LICENSEE: POWER AUTHORITY OF THE STATE OF NEW YORK

FACILITY: INDIAN POINT, UNIT NO. 3

SUBJECT: SUMMARY OF MEETING ON AUGUST 7, 1979, TO DISCUSS RESOURCE RECOVERY SYSTEM INTERFACE WITH INDIAN POINT, UNIT NO. 3

PLAN A - INJECT MSW STEAM INTO IP 3 SECONDARY STEAM CYCLE

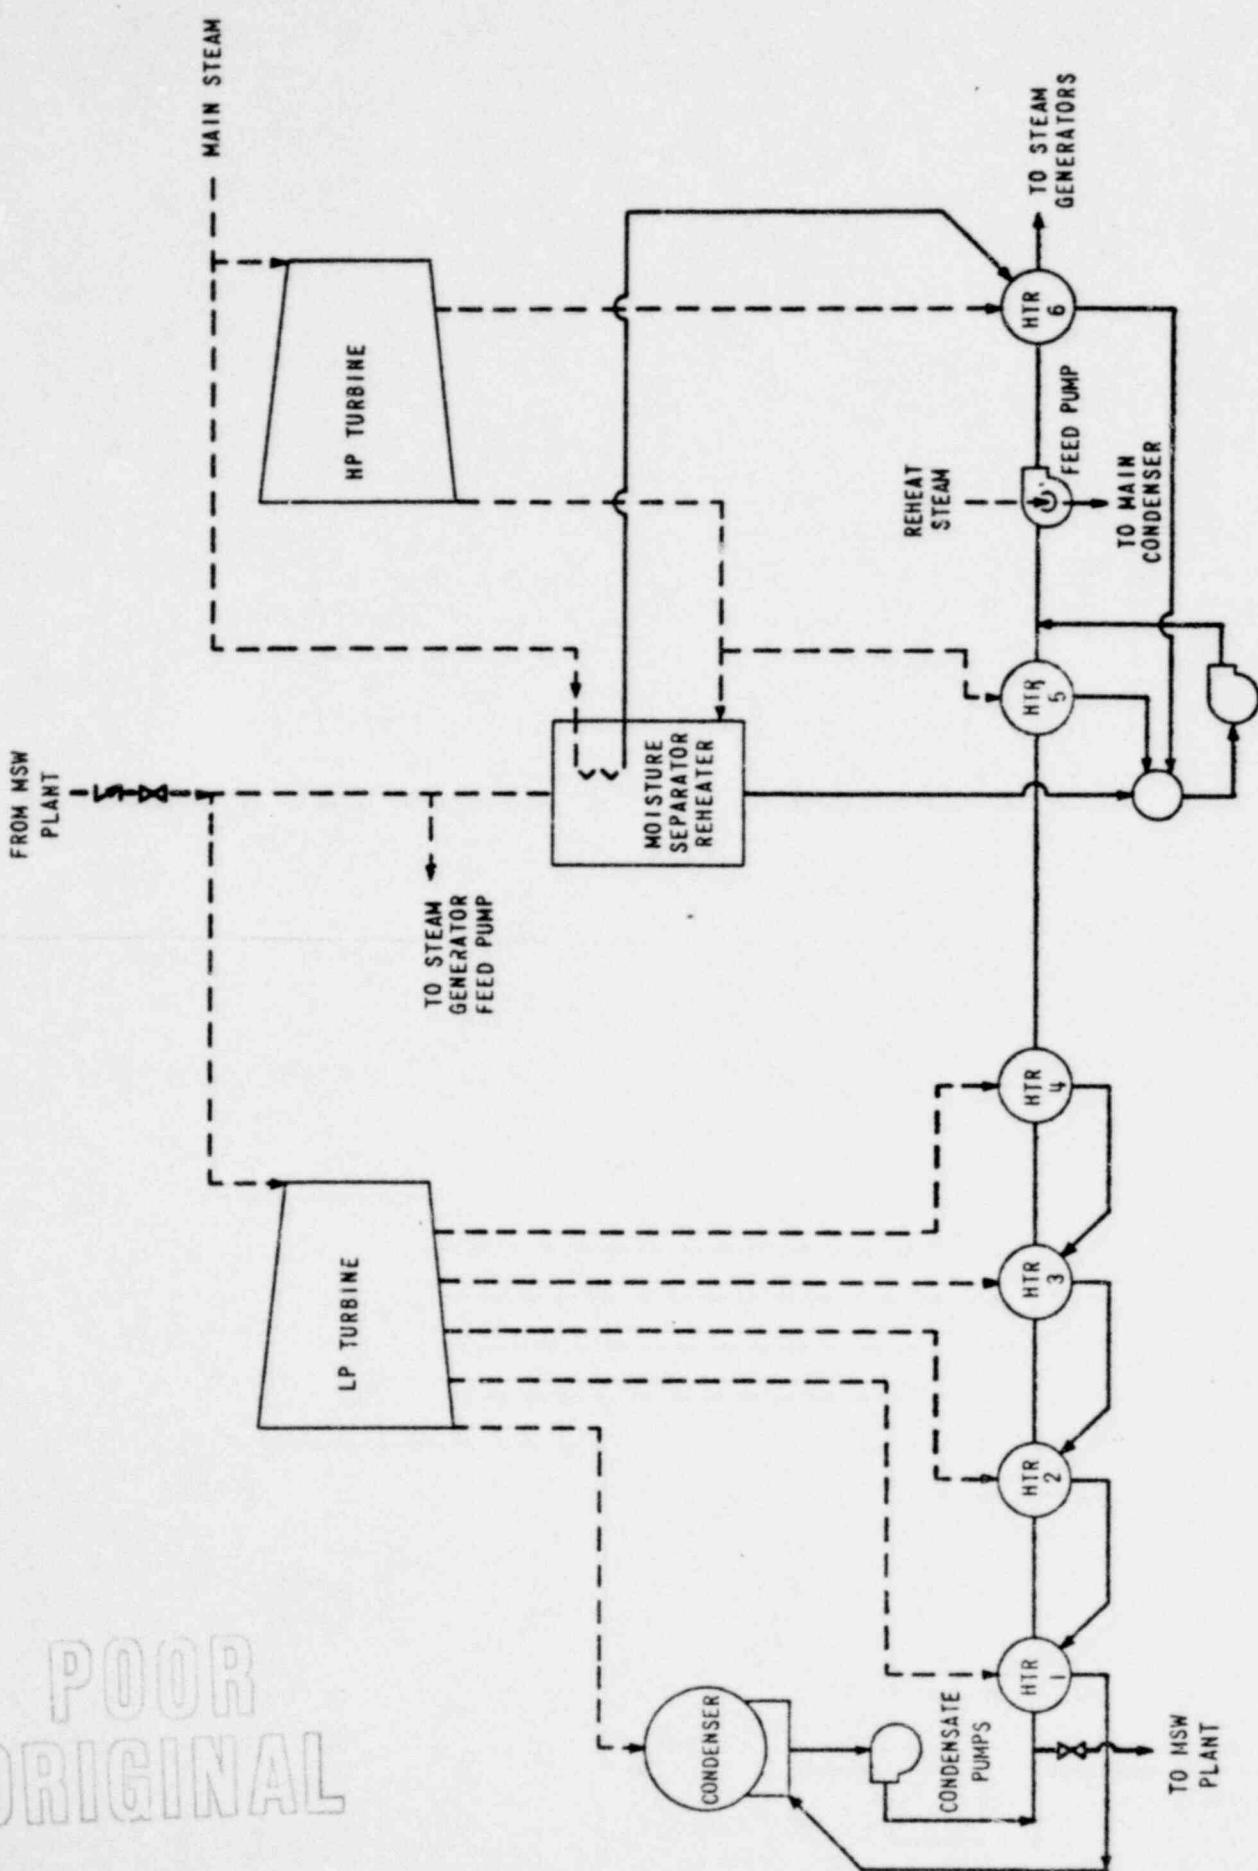
- (1) In several of the plans (especially Plan A), a steam generator tube leak could result in the transfer of radioactive water to the MSW facility. Therefore, radiation monitoring of the return line to the MSW facility would be required.

**PLAN B - USE MSW STEAM TO HEAT AN
ADDITIONAL IP 3 FEEDWATER HEATER**

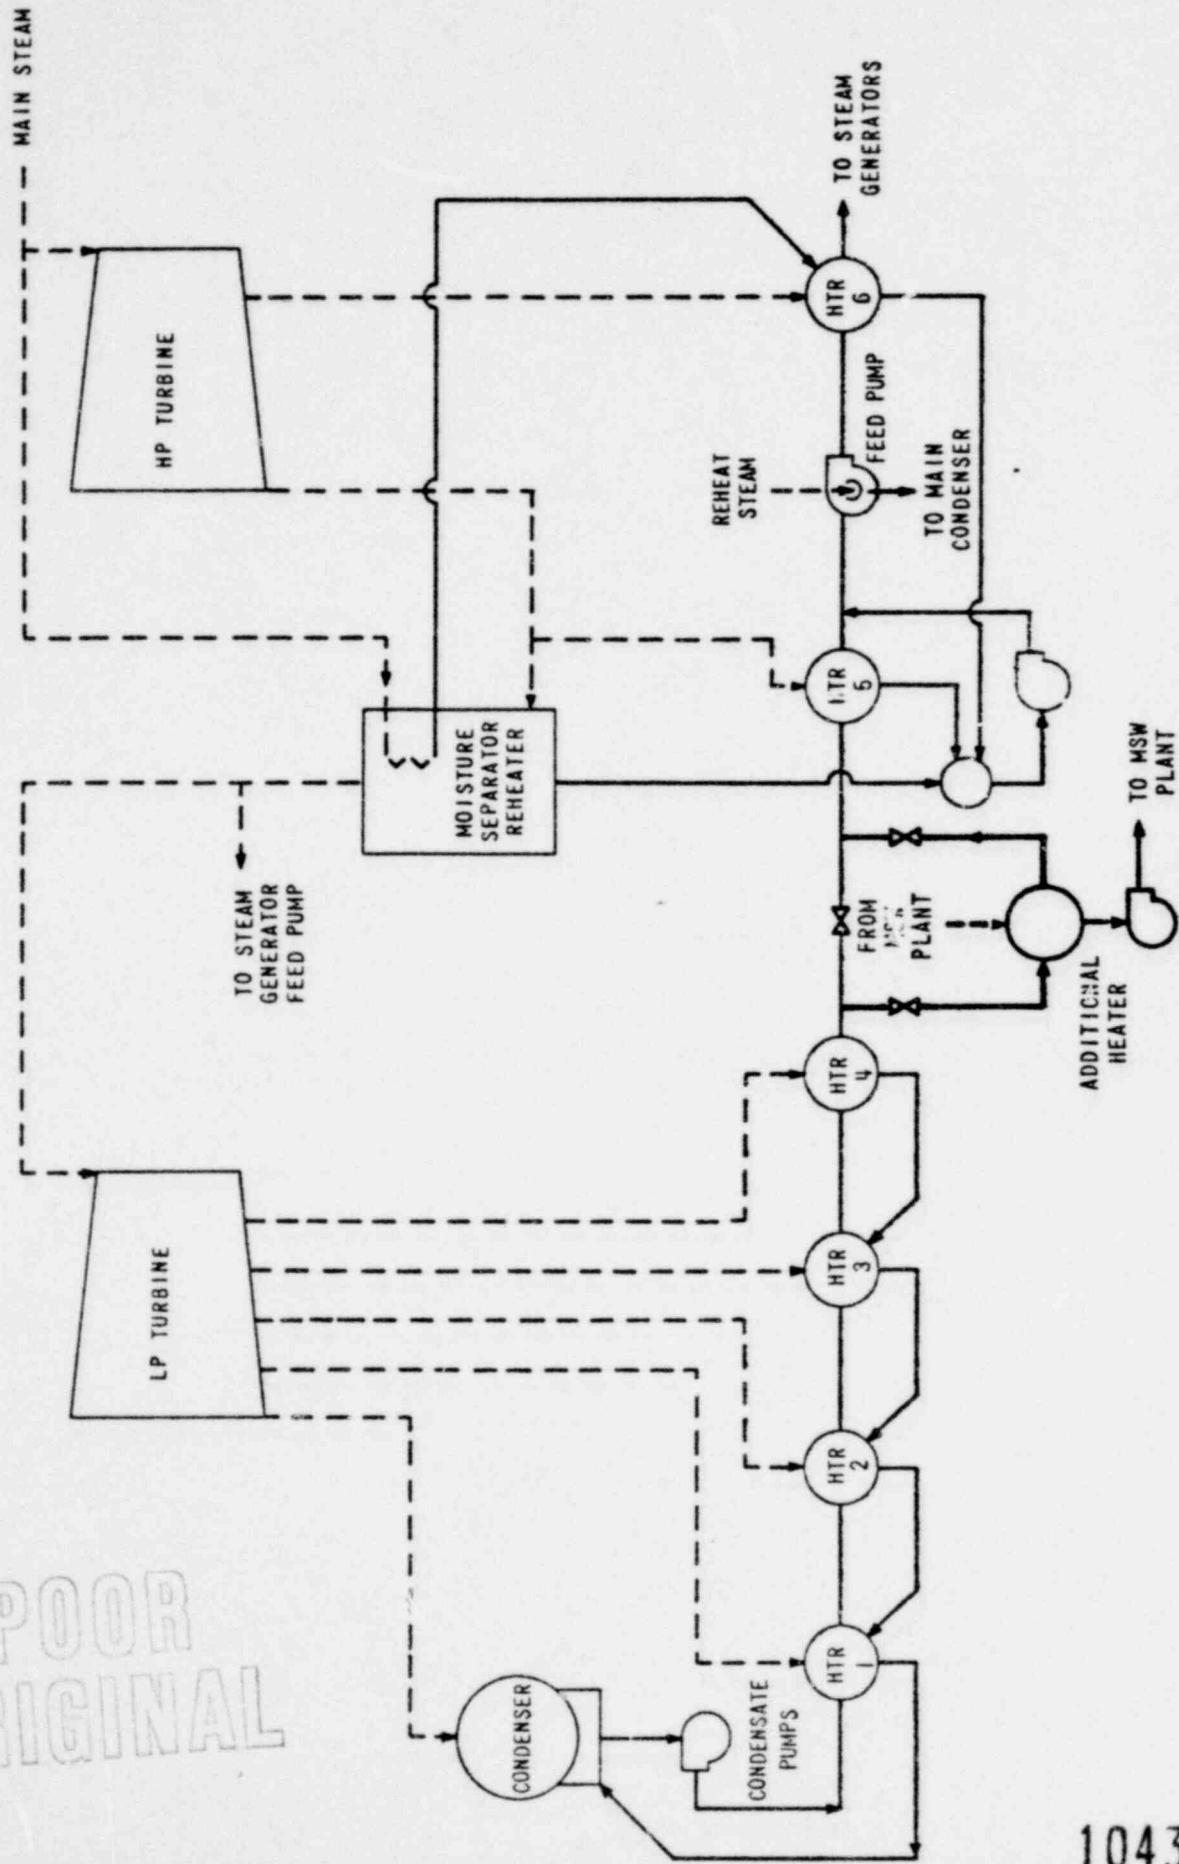
- (2) The licensee should determine if the proposed plan increases the consequences or probability of accidents or transients. For example, in Plan B, the loss of feedwater heating and, in Plan C, the partial loss of feedwater are transients that should be reviewed.
